TENNESSEE VALLEY AUTHORITY

In the Matter of the Application of) Docket No 50-390
Tennessee Valley Authority)

On April 2, 1985, TVA and NRC representatives met to discuss various power system issues associated with the Watts Bar unit 1 technical specifications. During this meeting, TVA committed to provide additional information on several of the issues which were discussed. Enclosed is the information on several of these items. Consistent with the April 2 discussion, it is anticipated that this information will resolve these issues. Information on the remaining issues will be forwarded in the near future.

TECHNICAL SPECIFICATION 4.8.1.1.1.b - 6.9 kV
SHUTDOWN BOARDS

TYPICAL WBNP 6900-V SHUTDOWN BOARD
SCHEME

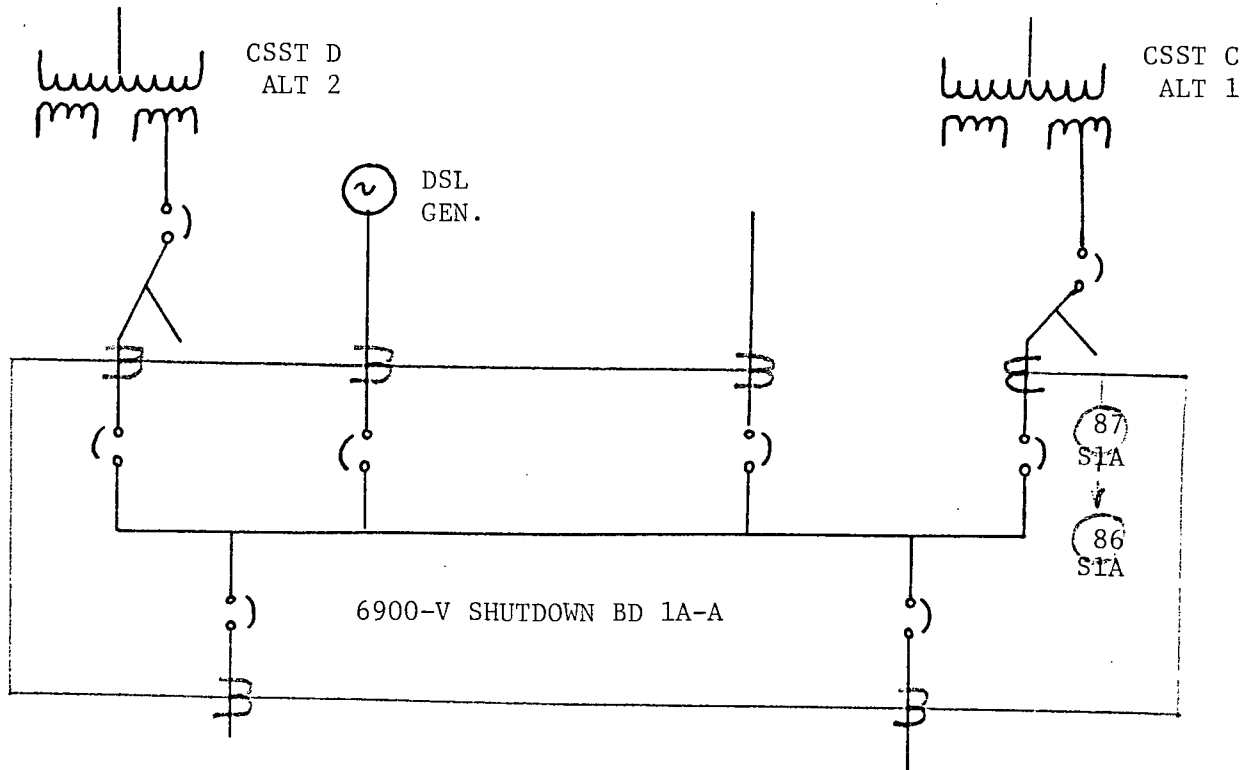
FAULTED BOARD LOCKOUT RELAY

Each 6.9-kV shutdown board is equipped with overcurrent and differential overcurrent protective relays to trip and lockout all supply breakers if a loss of voltage is caused by an overload or electrical fault, thus preventing transfer to a faulted bus.

The scheme is such that a fault (diff. OC) initiates the differential overcurrent relay (87S1A) which energizes the differential overcurrent slave relay (86S1A) which in turn initiates tripping and lockout of all the 6.9-kV shutdown board supply breakers.

The design of the protective scheme is such that it would require multiple failure to incapacitate both offsite power sources.

A single event such as a fault and a stuck breaker will not be transferred to the other supply because of the design logic which utilizes auxiliary contacts of the closed breaker in the close circuit of the alternate supply breakers, thus preventing transfer to the other source.

Failure of the protective relaying 87S1A or 86S1A will prevent tripping of the closed breaker. Since the 86S1A relay initiates the trip and lockout of all supply breakers to the affected board, utilizing contacts operated off the same shaft it is unlikely to assume a trip and no lockout.

Trip and lockout verification testing of the protective relays to the 6.9-kV shutdown boards was performed on Pre-operational Test - TVA 13A-RT. Any further testing of the overcurrent or differential overcurrent relay will have to be performed with both units in Mode 5 or Mode 6 only since performance of this test renders the diesel generator (supplying the board being tested) inoperable, that train of shutdown boards inoperable, and possibly result in unnecessary start of the diesel generator.
